**SUBJECT:** R.E. Ginna Nuclear Power Plant  
Docket No. 50-244

**Supplemental Response to Requests for Additional Information Regarding  
Topics Described by Letters Dated August 24, 2005 and October 28, 2005**

ATTACHMENT 2  
RESPONSES TO NRC RAIs 2, 3, 5 REGARDING POST-LOCA LONG-TERM COOLING  
OCTOBER 28, 2005

ATTACHMENT 3  
RESPONSES TO NRC RAIs REGARDING LOCA ANALYSES  
AUGUST 24, 2005

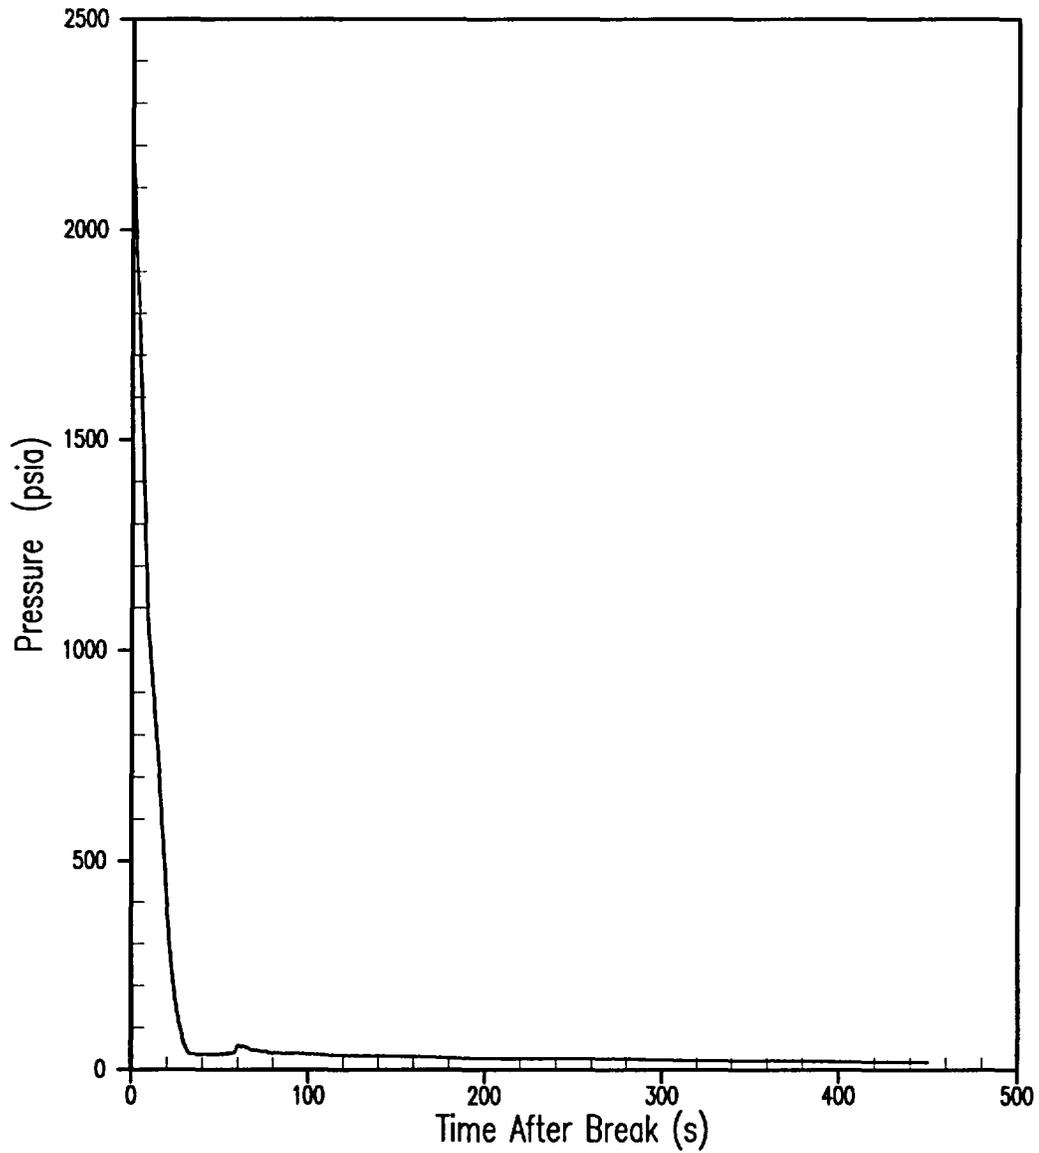
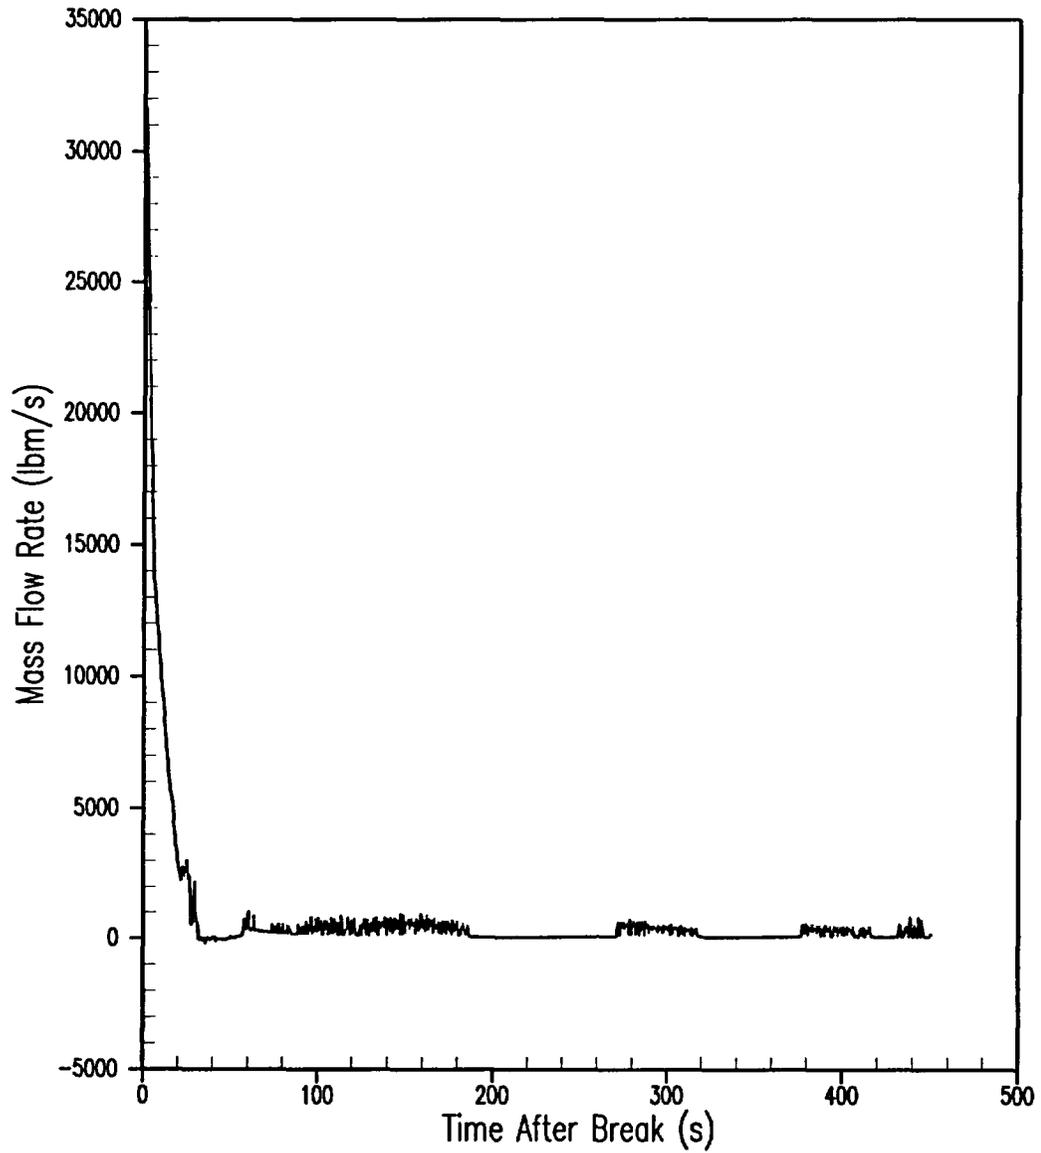
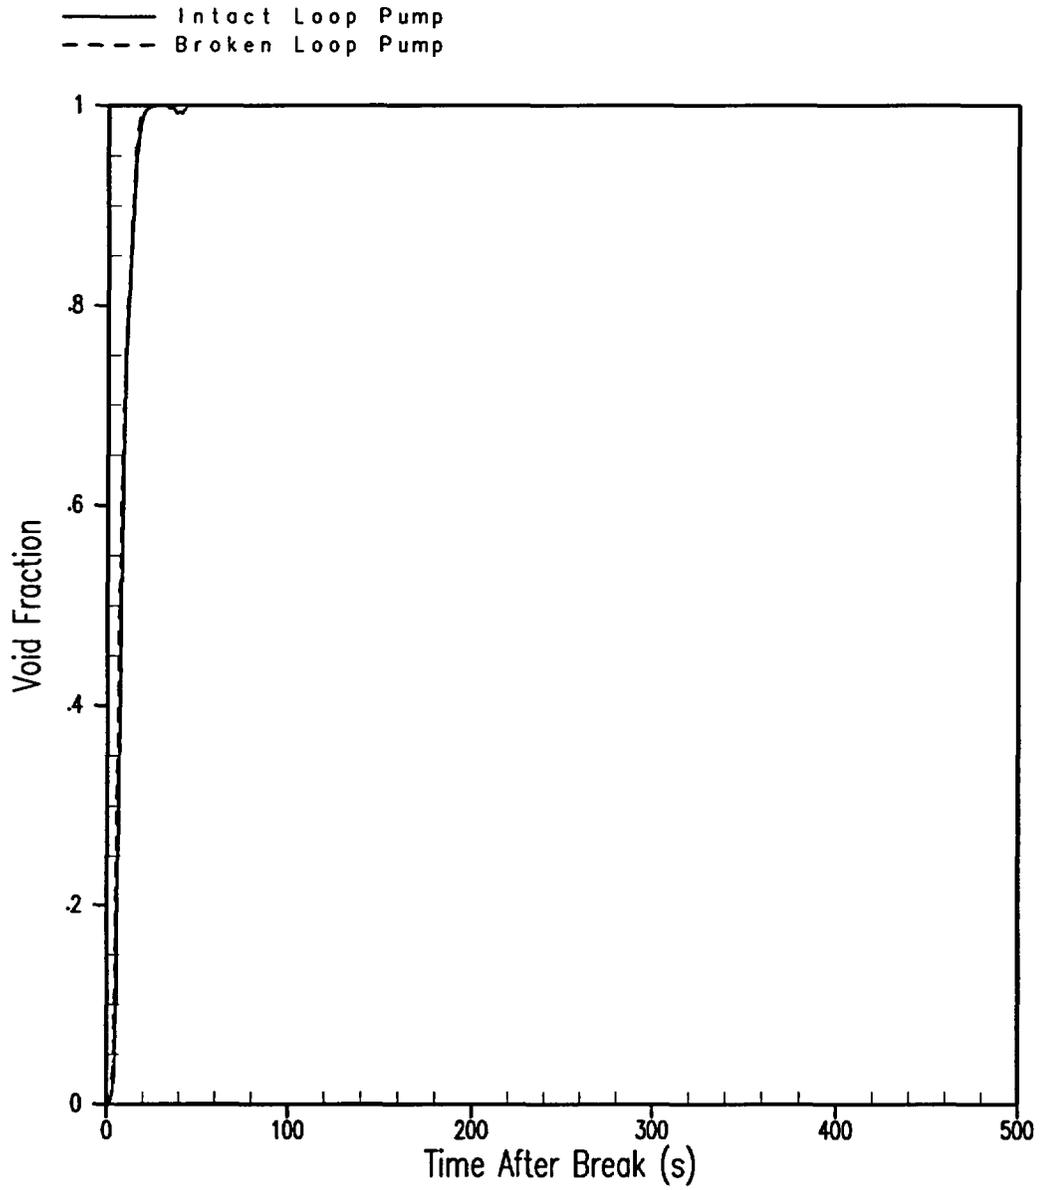
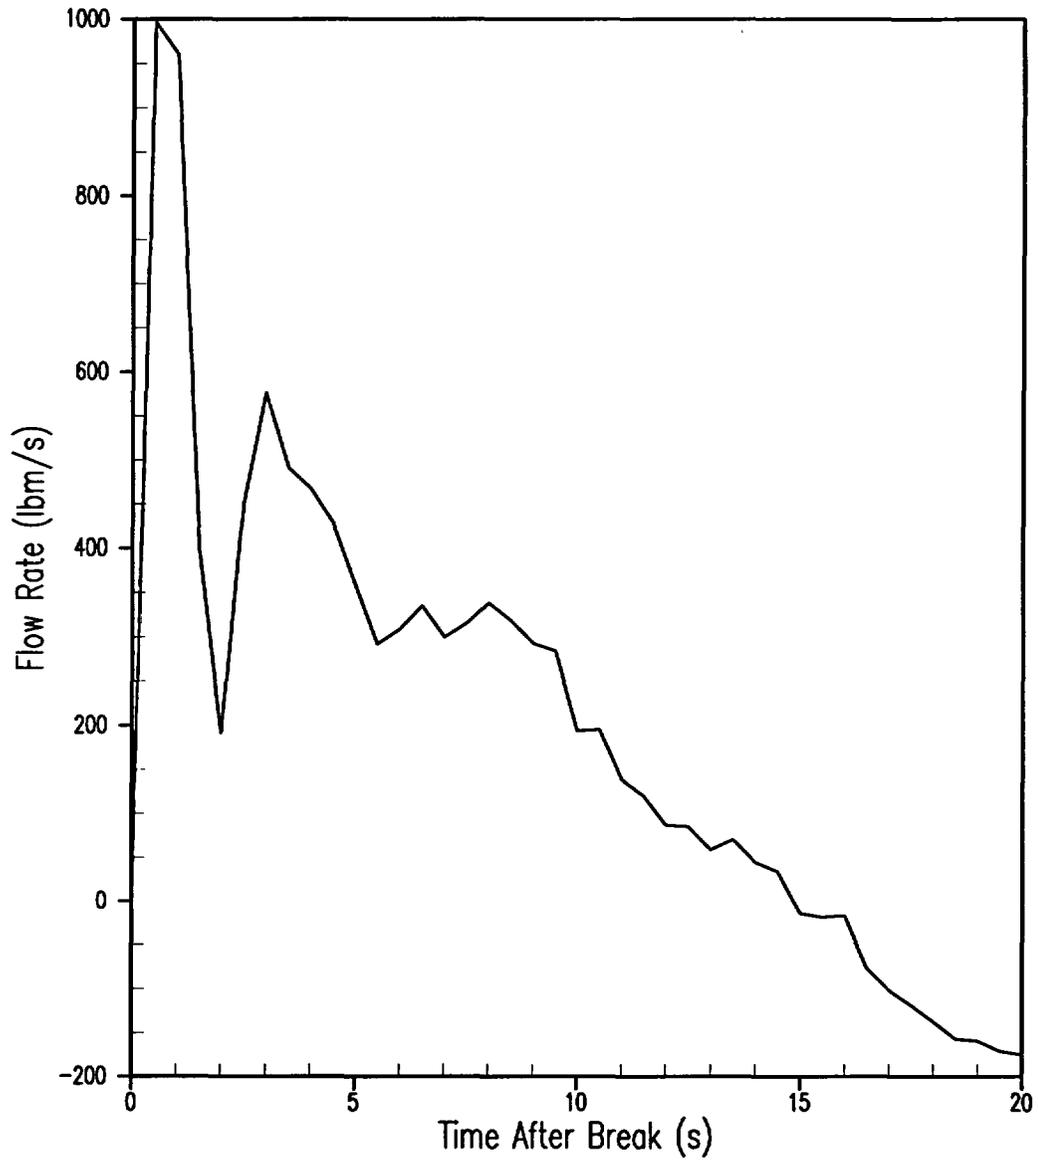
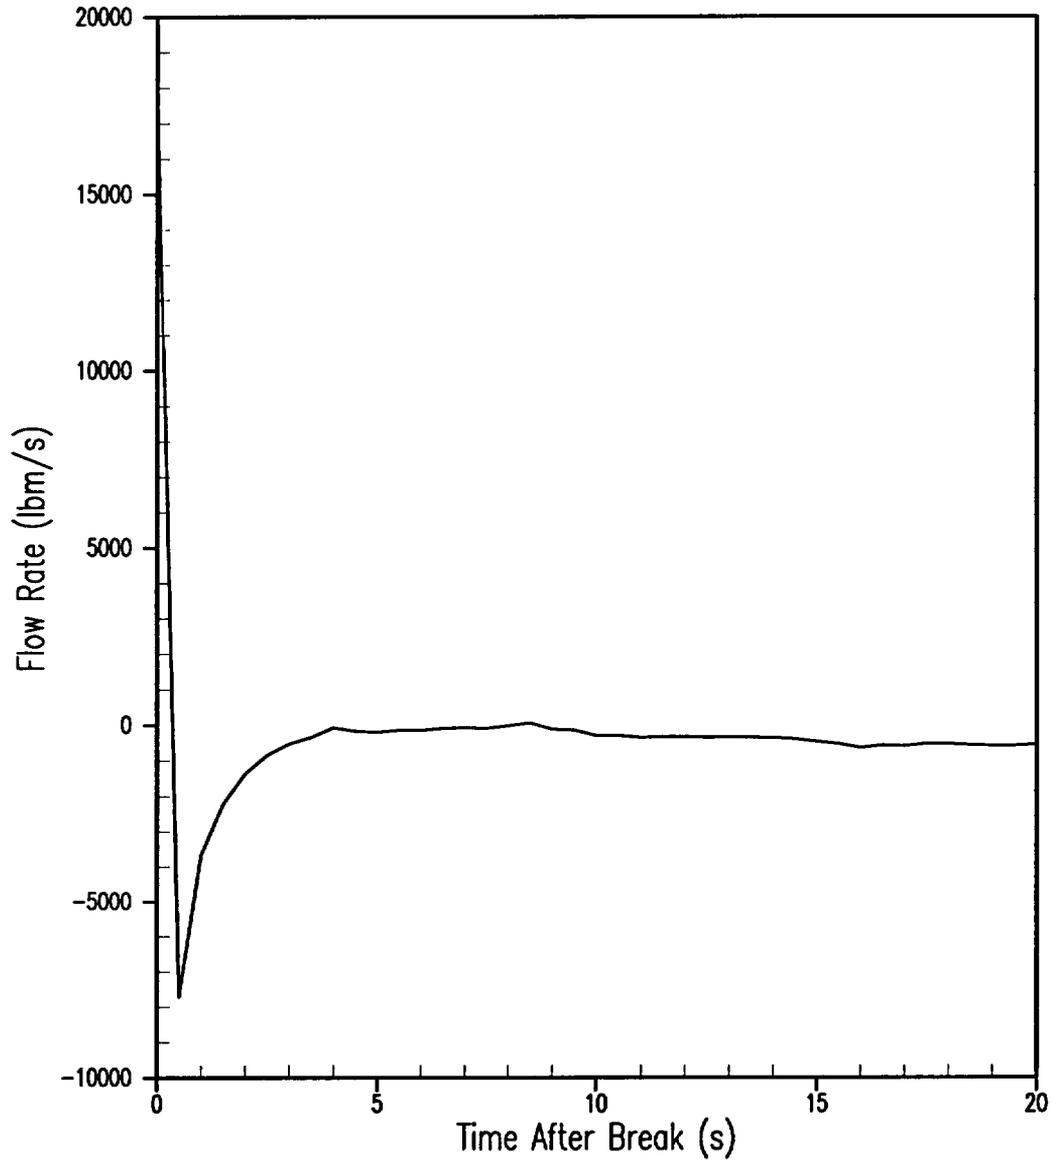
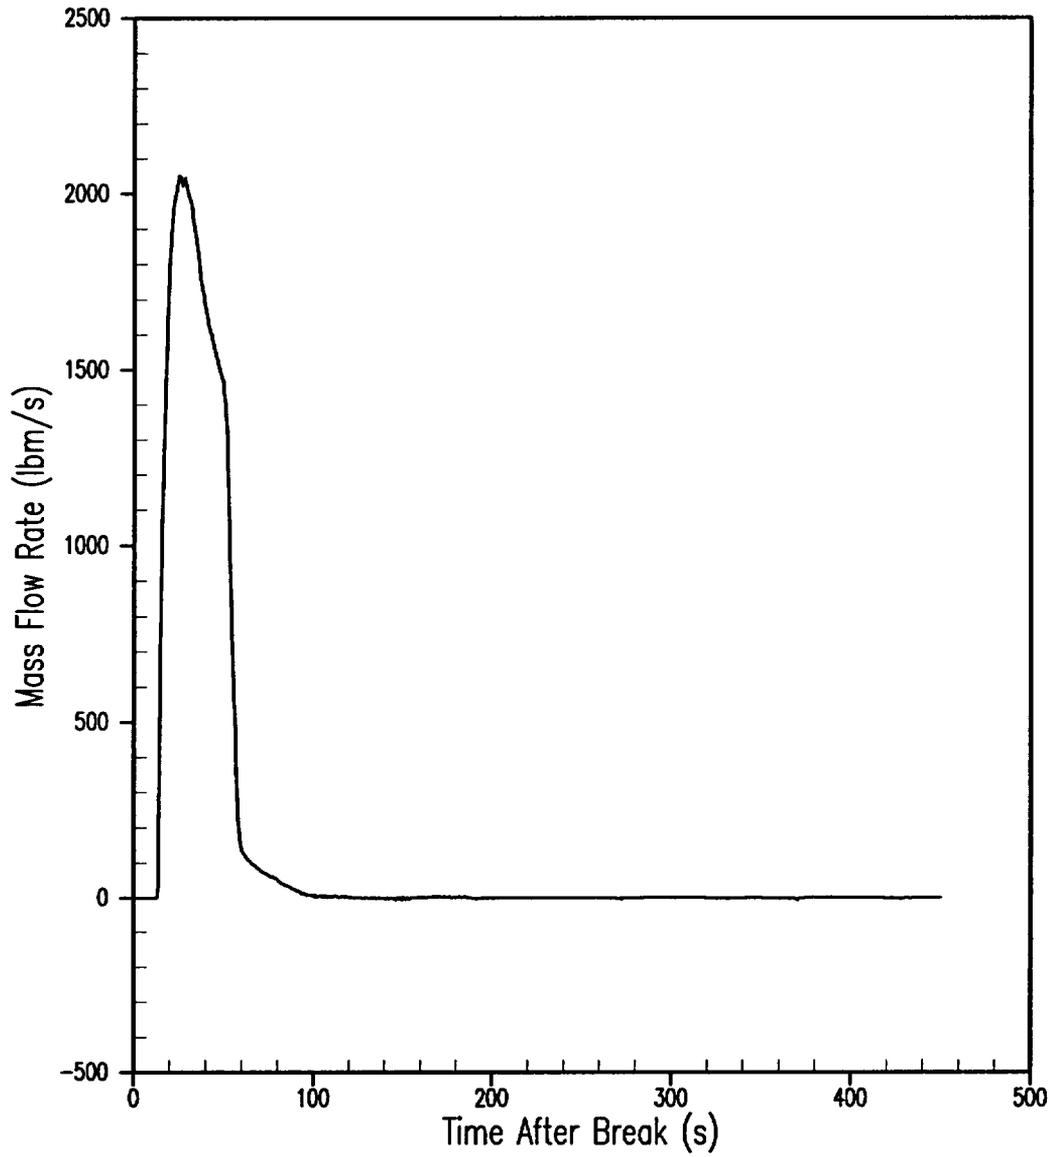
Additional analysis results are also required for the best-estimate large-break LOCA analysis. Only the PCT plot for the hot rod and hot bundle were provided for the limiting break.

Provide the complete analysis results including all of the key major response parameters. Also, did the analysis include downcomer boiling effects and what was the worst single failure if downcomer boiling occurs? What containment pressure was assumed?

Figure 1.1 is a plot of the pressurizer pressure throughout the transient. Figure 1.2 is a plot of the mass flow rate through the split break, and Figure 1.3 of the void fraction in both the intact and broken loop pumps. Figure 1.4 is a plot of the vapor flow rate at the top of the core for the first 20 transient seconds, and Figure 1.5 a plot of the total flow rate at the bottom of the core for the same time period.

Figure 1.6 is a plot of the accumulator injection flow, Figure 1.7 a plot of the High Head Safety Injection Flow into the intact cold leg, and Figure 1.8 a plot of the Low Head Safety Injection Flow into the upper plenum. Figures 1.9, 1.10, and 1.11 are plots of the lower plenum, downcomer, and core collapsed liquid levels, respectively. The reference point for the lower plenum liquid level is the bottom of the vessel. The reference point for the downcomer liquid level is the point at which the outside of the core barrel, if extended downward, intersects with the vessel wall. The reference point for the core collapsed liquid levels is the bottom of the active fuel.
